**PARTS & SERVICE NEWS**

AH03534

**SUBJECT:** Hydraulic oil level indicator with floating ball

**APPLICATION:** PC3000; PC4000; PC5500; PC8000 All Serial Numbers

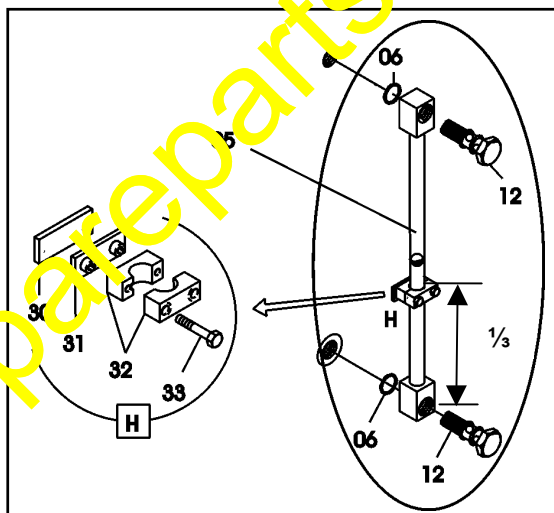
**PURPOSE:** Easy viewing of the hydraulic oil level

Pos.	Number	Part no.	Name
05* (PC3000)	1	907 594 40 (780 mm)	Fluid level indicator with ball
05* (PC4000)	1	907 564 40 (450 mm)	Fluid level indicator with ball
05* (PC5500)	1	907 564 40 (960 mm)	Fluid level indicator with ball
05* (PC8000)	1	907 604 40 (1139 mm)	Fluid level indicator with ball
30	1	652 801 40	Plate
31	1	533 989 99	Glue on plate
32	2	502 631 98	Half clamp
33	2	319 132 99	Bolt

1. Replace the fluid level indicator with position (05).
2. Attach the plates (30) and (31) at 1/3 of the length of glass tube (05).  
Clean the surface carefully and use a 2 components glue.
3. Install the half clamps (32) for supporting the glass tube.
